City of Richmond

Report to Development Permit Panel

File: DP 18-829082

Re: **Application by Forest International Real Estate Investment Company Ltd. for a Development Permit at 10231, 10251, 10351, 10371, 10391, 10395 and 10397 No. 2 Road**

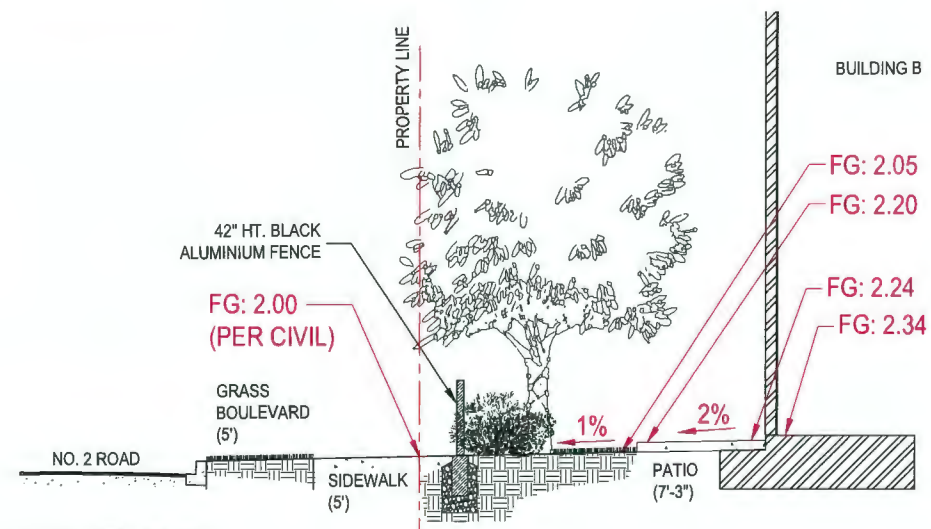
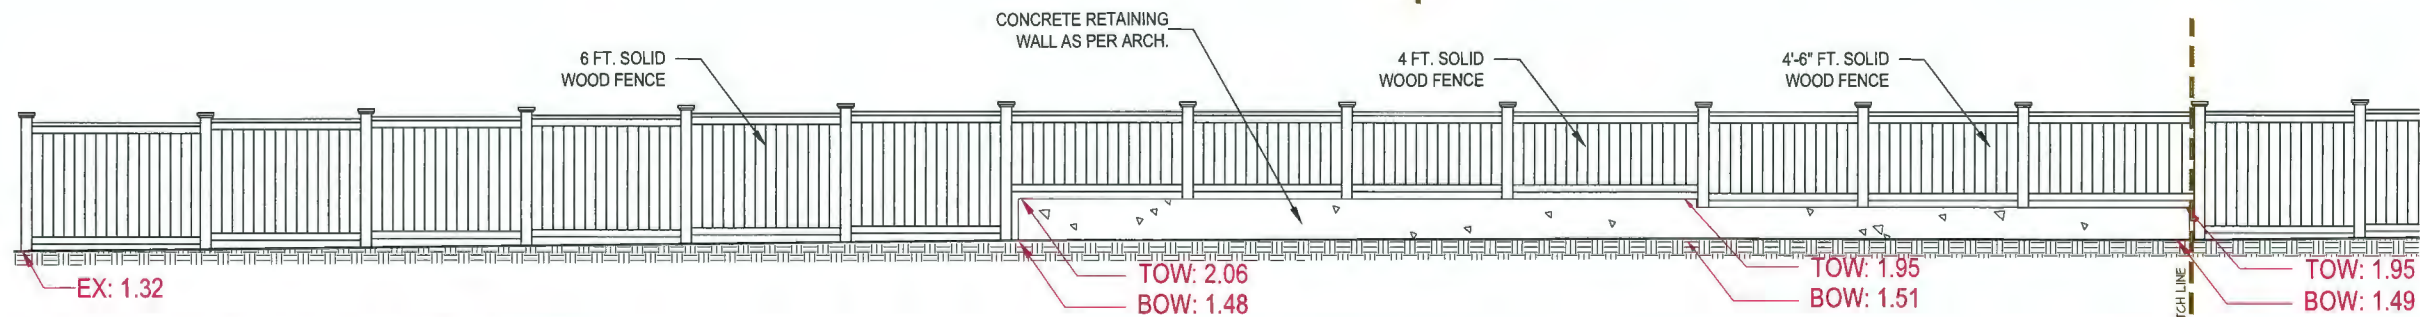
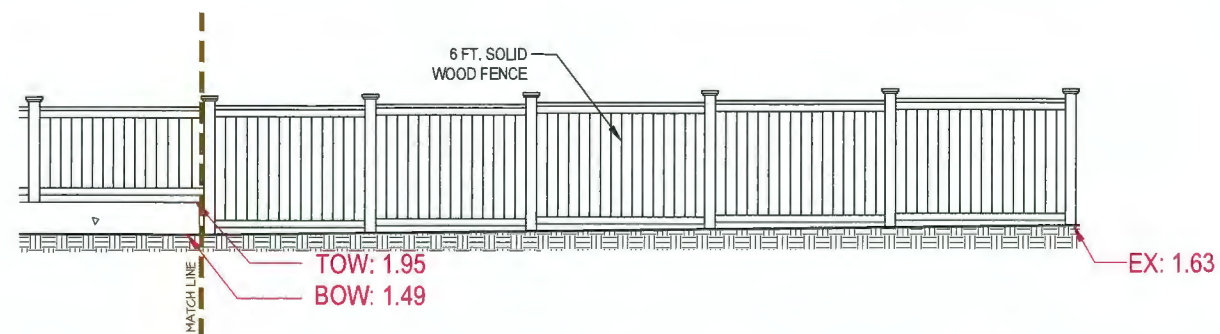
- landscape section details on Drawing L15 in the submission package indicate that the back yards of the rear duplex units are not accessible; a 4.9 percent slope for the patio and 8.5 percent slope for the sod lawn are not appropriate;

Steep slope has been alleviated through revised grading and steps. Max slope is 2% in all yard areas for accessibility. Landscape sections updated
